CS Memorandum No. 1411

**Subject:** Configuration Management Board Meeting No. 120

## CMB Meeting Minutes #120

SUBJECT: Configuration Management Board Meeting # 120 – Rev. No. 0

SHEET  
JG-04

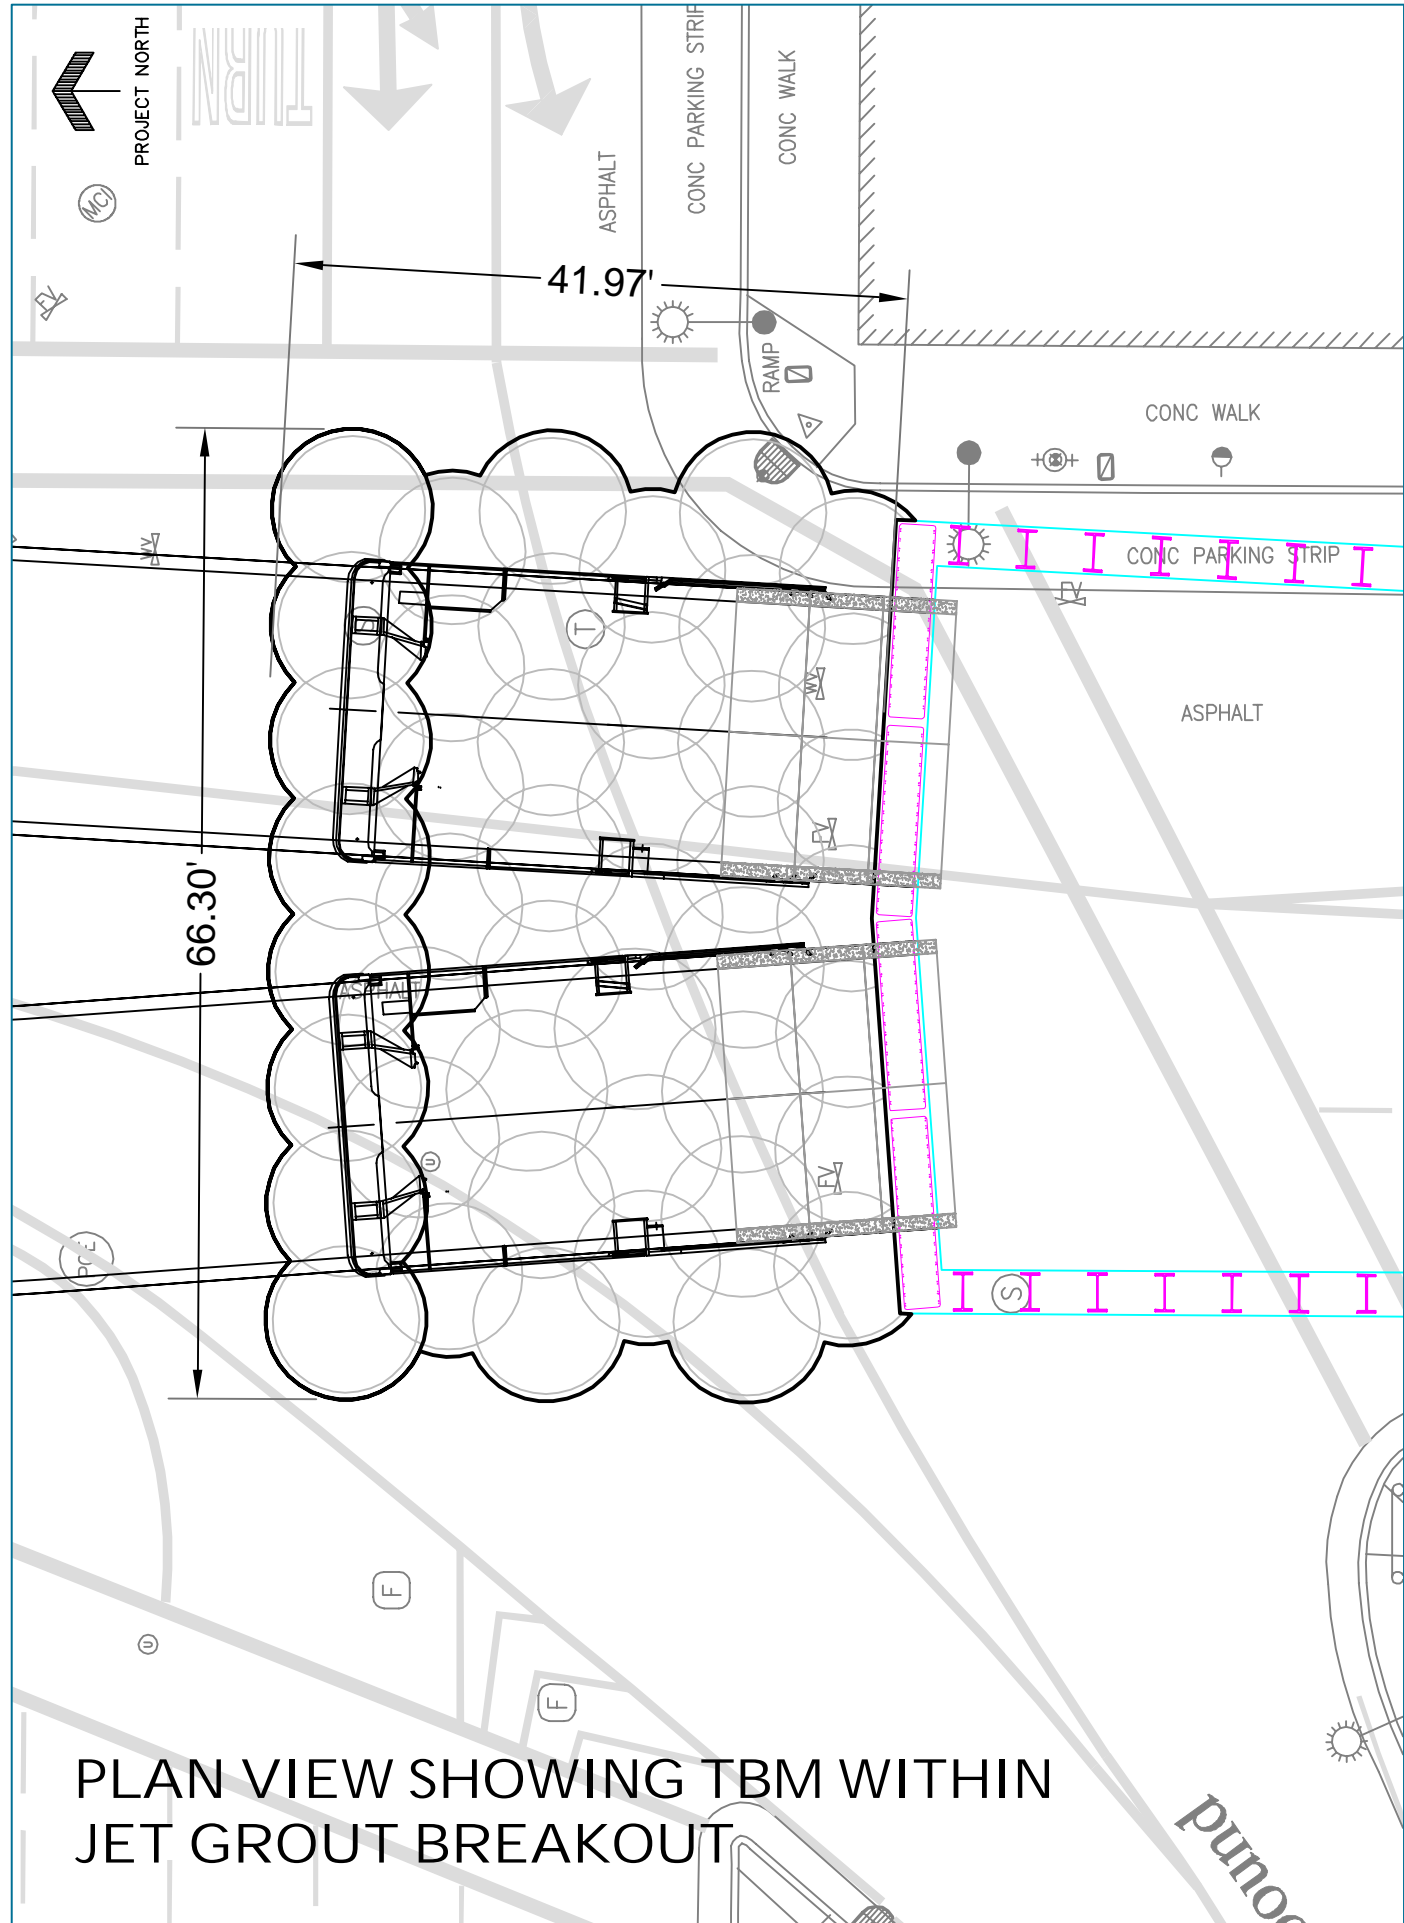
Contract Drawing ES-163 Rev.1 provides minimum dimensions for the extent of the ground treatment for the TBM launch box. A note on the plan and section view of the drawing also indicates that the TBM Breakout Ground Treatment is "Designed by Contractor." Note 8 on the same drawing states, "Grout to be designed by the Contractor. The Contractor shall develop the proposed grouting plans based on the conditions at the TBM Launch Box and the requirements shown on this sheet. The Contractor shall submit the proposed grouting plans to Engineer for review and approval."

The main purpose for having a Soilcrete breakout zone is to provide relatively impermeable ground for the TBMs to start mining within. The minimum dimensions were not sufficient to produce a large enough Soilcrete breakout zone for a safe TBM breakout because the overall length of the TBM shield and cutterhead exceeds the minimum length shown in the Contract Drawings (see attached drawings). The zone must be sized to allow installation and backfill grouting of at least one ring of the tunnel liner to provide a watertight seal to develop between the treated impermeable ground and the tunnel liner. Once a satisfactory seal has been developed, the TBM may safely exit the improved ground with a reduced risk of water and soil inflow into the tunnel/TBM Launch Box interface. The lack of a sufficient seal in un-improved ground would result in water and soil inflow which would likely cause significant and potentially catastrophic ground settlement at the breakout (i.e. the intersection of 4th and Harrison). The Contractor has designed the minimum jet grout layout to provide for the development of a sufficient seal. The design allows for the encapsulation of the TBM and one ring with

only 1.8' of cover between the TBM cutterhead and edge of jet grout. The Contractor will also provide additional protection by installing a breakout seal prior to mining.

PLEASE PROVIDE 1) QUANTITY CALCULATION  
2) HOW DID A LUMP SUM DESIGN BECOME A UNIT PRICE QUANTITY.

CONTRACT NO. <b>1252</b>
SFMTA CONTROL NO. <b>CL-17978</b>
DRAWING NO. <b>CS-114</b>
SHEET NO. <b>1</b>

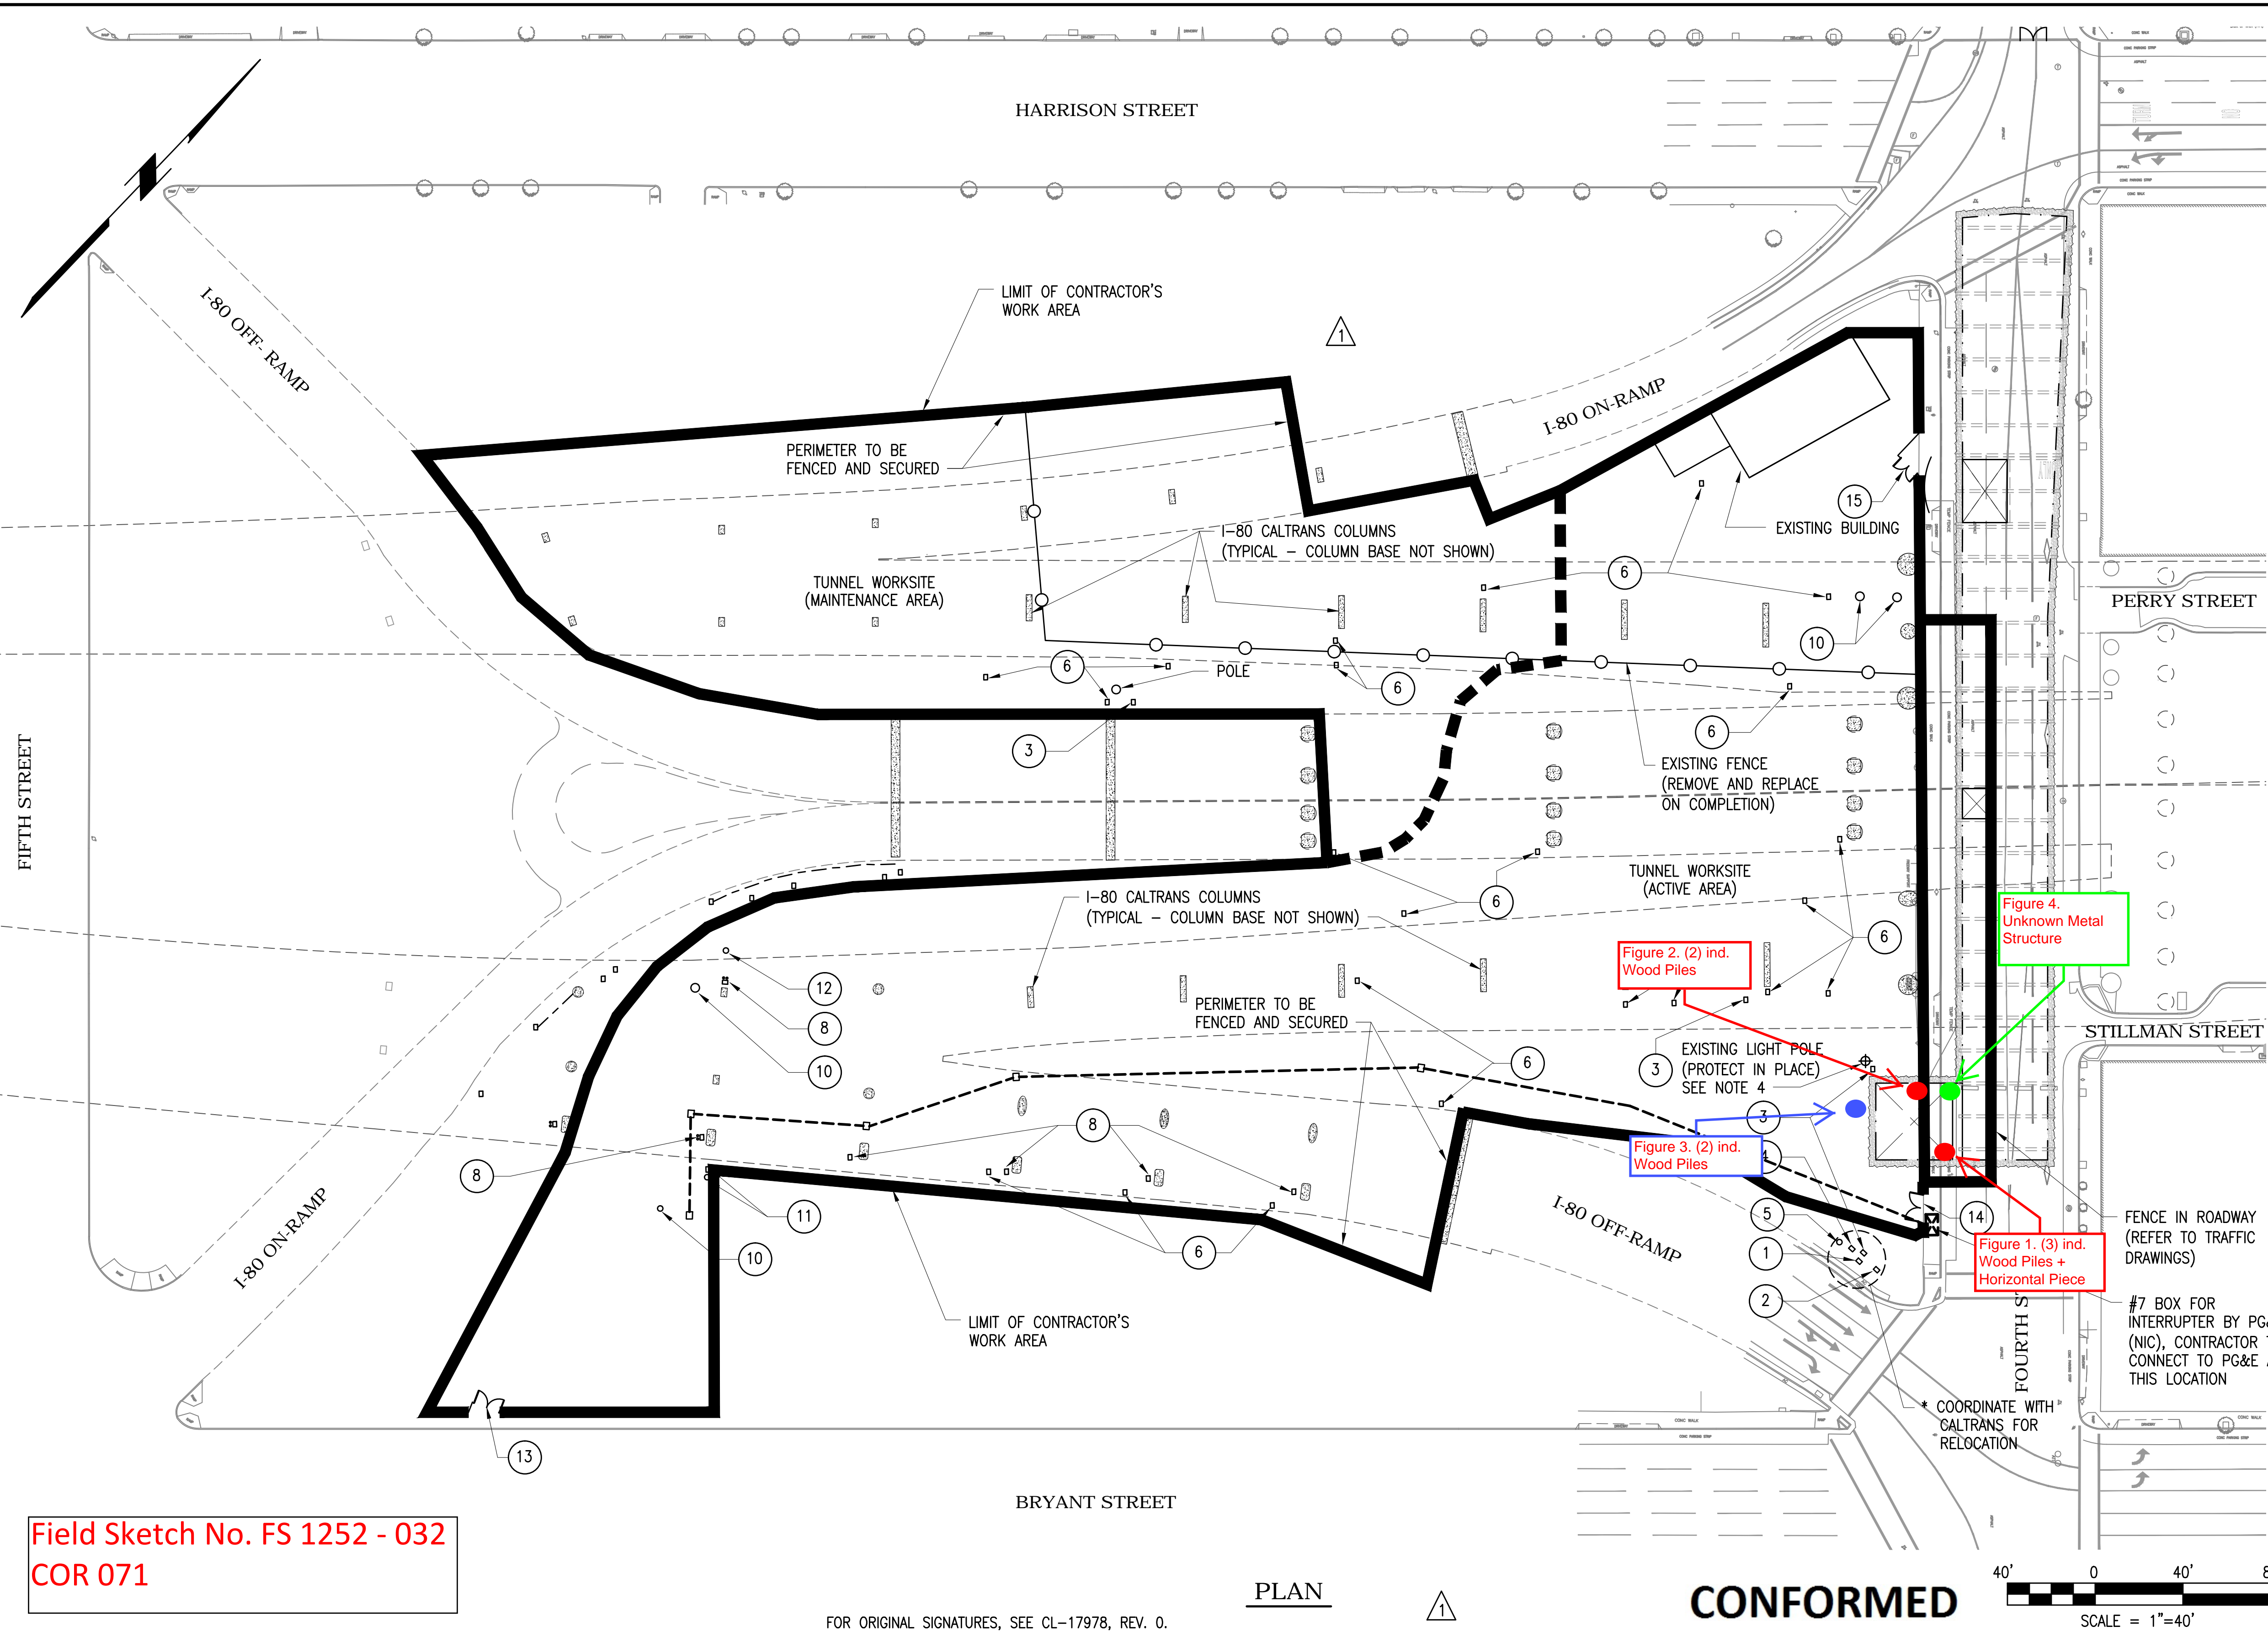
**Facts:** In January 2013 the Contractor encountered two groups of wood piles in the footprint of the Launch Box ramp while performing the ramp excavation. The wood piles consisted of 2 groups of individual wood piles, approximately 16"+ in diameter with an unknown depth located along the north and south perimeter walls of the excavation area. The south perimeter wall group of wood piles consisted of 3 individual wood piles and 1 horizontal section of wood atop all (See attached Figure 1). The north perimeter wall group of wood piles consisted of 2 individual wood piles (See attached Figure 2). The limits and make-up of all wood piles are unknown. Removal of a portion of each group of wood piles has occurred and efforts to remove the piles were witnessed by the SFTMA inspectors.

In February 2013 the Contractor encountered one group of wood piles and an unknown buried metal structure in the footprint of the Launch Box ramp while performing the ramp excavation. The wood piles consisted of 1 group of 2 individual wood piles, approximately 16"+ in diameter with unknown depth located along the north perimeter wall of the excavation area (See attached Figure 3). The unknown buried metal structure consists of a circular metal object; approximately 24" in diameter (See attached Figure 4). The limits and make-up of the wood piles and metal structure are unknown. Removal of a portion of these wood piles and unknown metal structure has occurred and efforts to remove these obstructions were witnessed by the SFTMA inspectors.

The Contractor has installed a ramp in place of where a shaft was originally shown in the Contract Drawings. Most of the wood piles are located within the Launch Box excavation footprint and the original shaft footprint. The attached sketch FS 1252 – 032 shows the location of the wood piles superimposed onto Contract Drawing CS-114 Rev.1.

**Justification:** The wood piles discovered in January and the unknown metal structure lie within the original Launch Box shaft excavation limits and constitute a differing and unforeseen site condition as they were not shown in the Contract Documents, specifically Drawing CS-114, Rev. 1 or the Geotechnical Baseline Report. Additional labor and equipment costs are anticipated for removal and disposal of these obstructions.

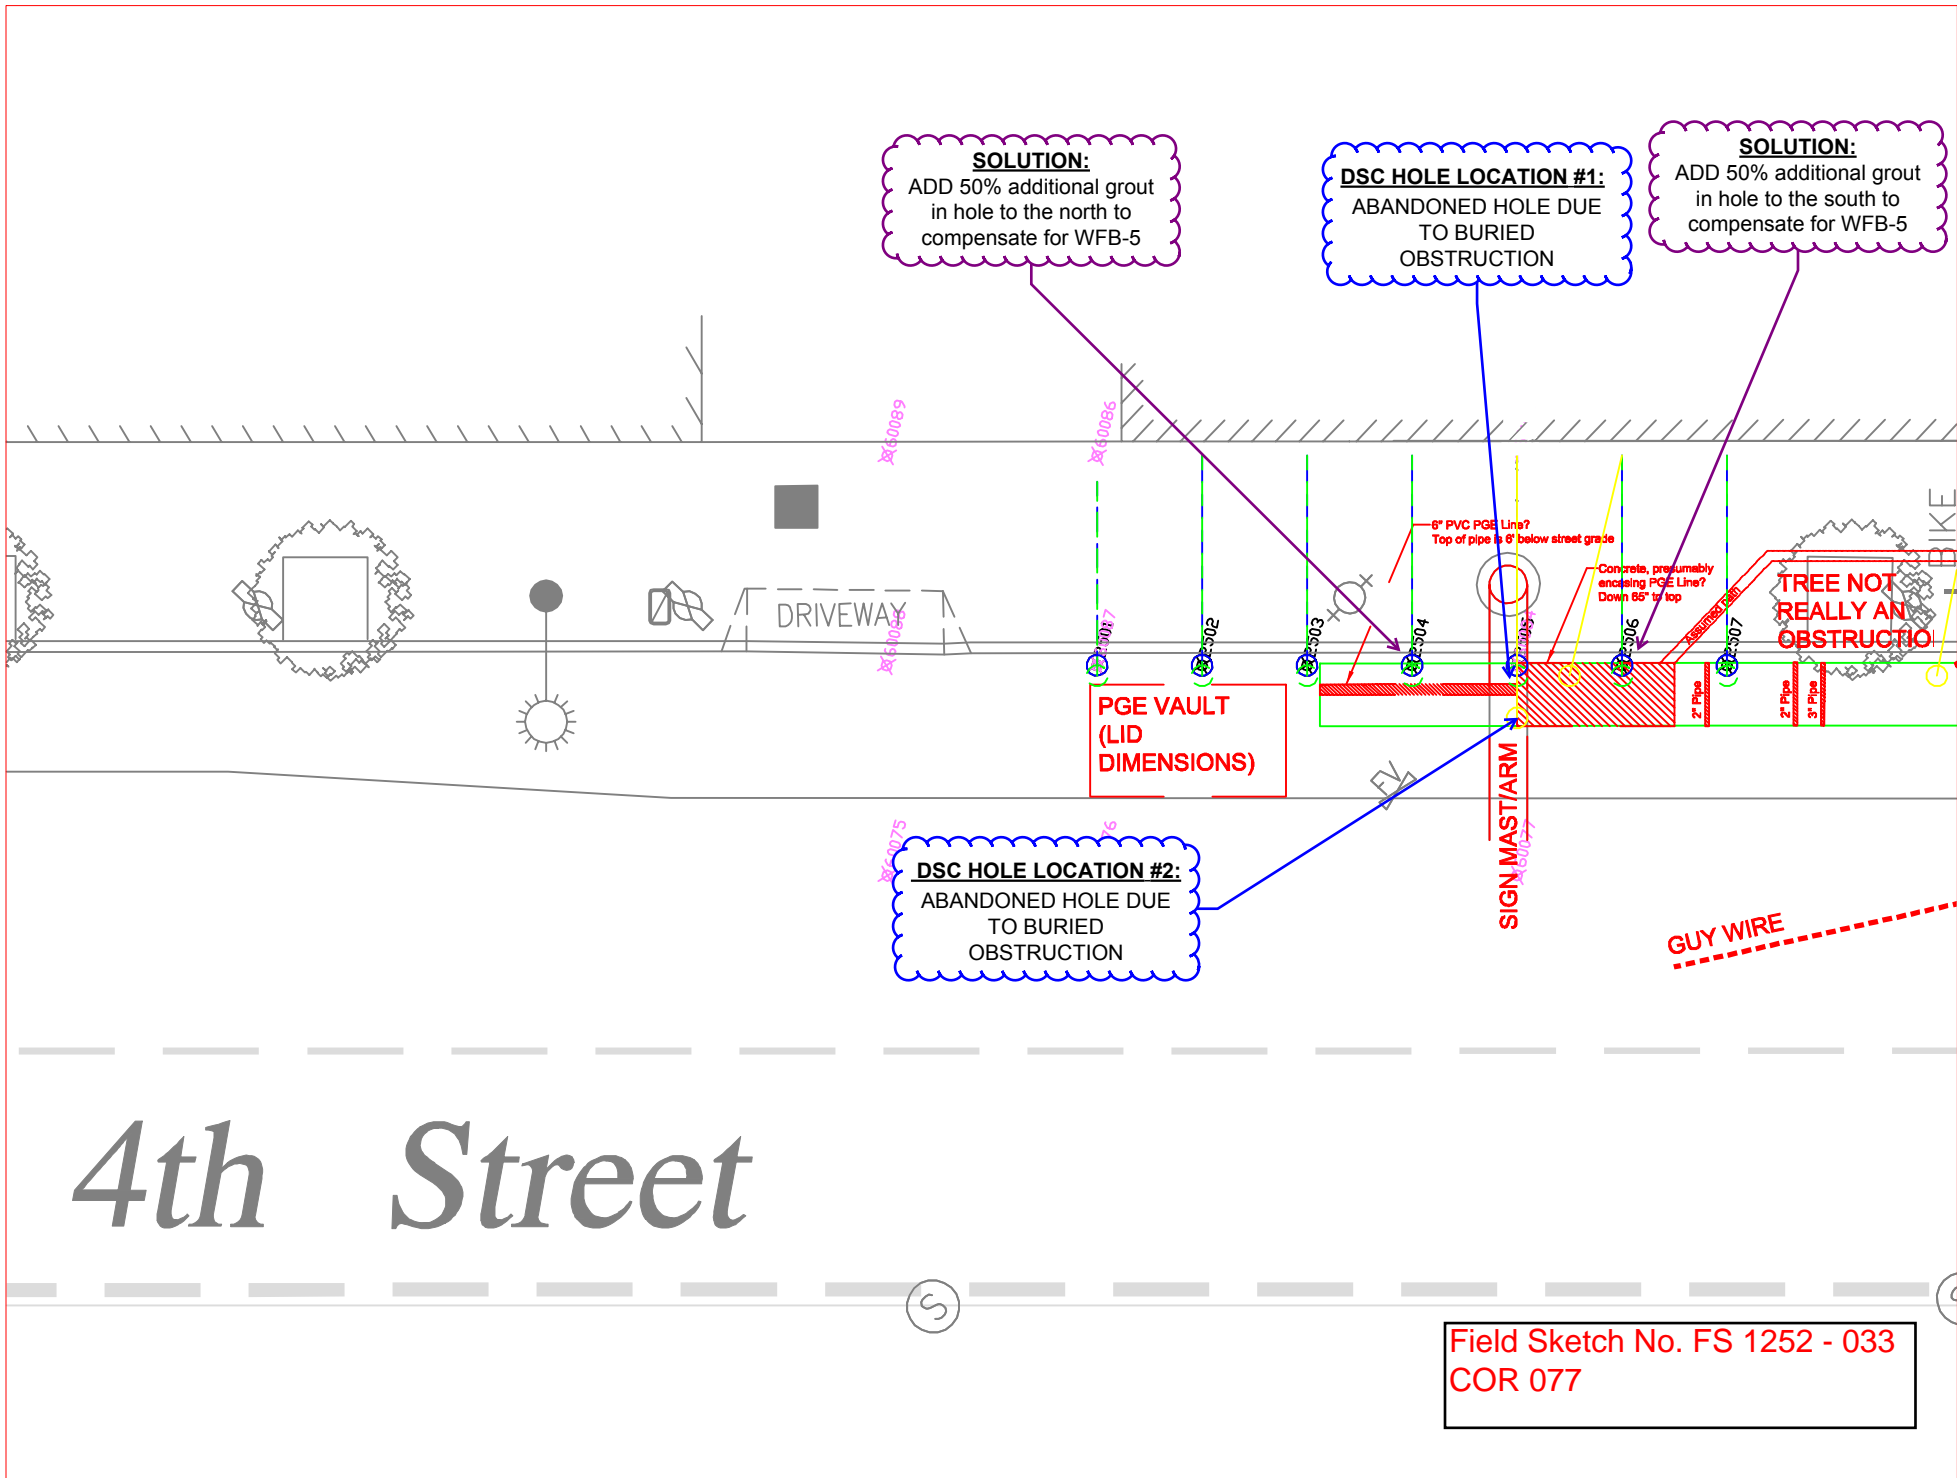
**Facts:** While drilling for compensation grout hole WFB-5 at approximate CTL station 160+38, the Contractor encountered an unknown obstruction at a depth of 9' which prevented installation of WFB-5 per design. After further field investigation, including the use of a vacuum truck, and attempts to re-drill the hole it was determined that it was not feasible to install a drill hole at the original planned location.

The Contractors designer (Arup) confirmed that it would be acceptable to relocate the location of the hole by approximately 2' to the west. The Contractor drilled at the modified location and encountered another obstruction at 13' in depth. In response, additional engineering was performed by the Contractors designer in order to eliminate compensation grout hole WFB-5 by modifying grouting procedures of the adjacent drill holes. See attached sketch FS 1252 – 033 for more details.

**SOLUTION:**  
ADD 50% additional grout  
in hole to the north to  
compensate for WFB-5

**SOLUTION:**  
ADD 50% additional grout  
in hole to the south to  
compensate for WFB-5
